Case number 214636

## Feasibility letter

<b>Developer:</b>	<b>Proficient Constructions (Aust) Pty Ltd</b>
<b>Your WSC's reference:</b>	<b>24-0142</b>
<b>Development:</b>	<b>Lot 3 DP1201486 80 SILVERDALE RD, The Oaks</b>
<b>Development description:</b>	<b>Currently Vacant Land zoned RU2, Proposed development R5 Large Lot Residential 9 lots</b>
<b>Your application date:</b>	<b>April 22, 2024</b>

**SUBMISSION OF DRAFT PLANNING PROPOSAL – 80 SILVERDALE RD, THE OAKS 2570**

**Figure 3**

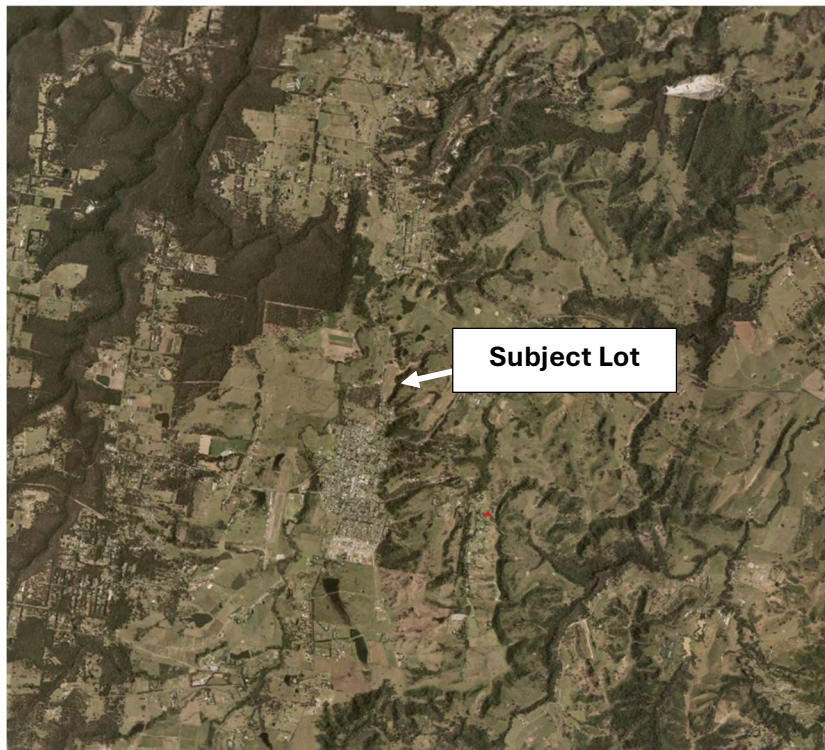
**Figure 3** details the landscape affecting a bushfire approaching the subject land.

1. Bushfire hazards (bushland) in north, east and west directions.
2. Grassland and fragmented forest vegetation to the north, with significant forest vegetation approximately 870m to the northwest of the property boundary.
3. Remnant vegetation especially around the riparian areas and grassland to the east.
4. Mostly grassland to the west with a remnant piece of forest vegetation directly opposite the lot and further forest vegetation approximately 1.6 kilometres from the property boundary.
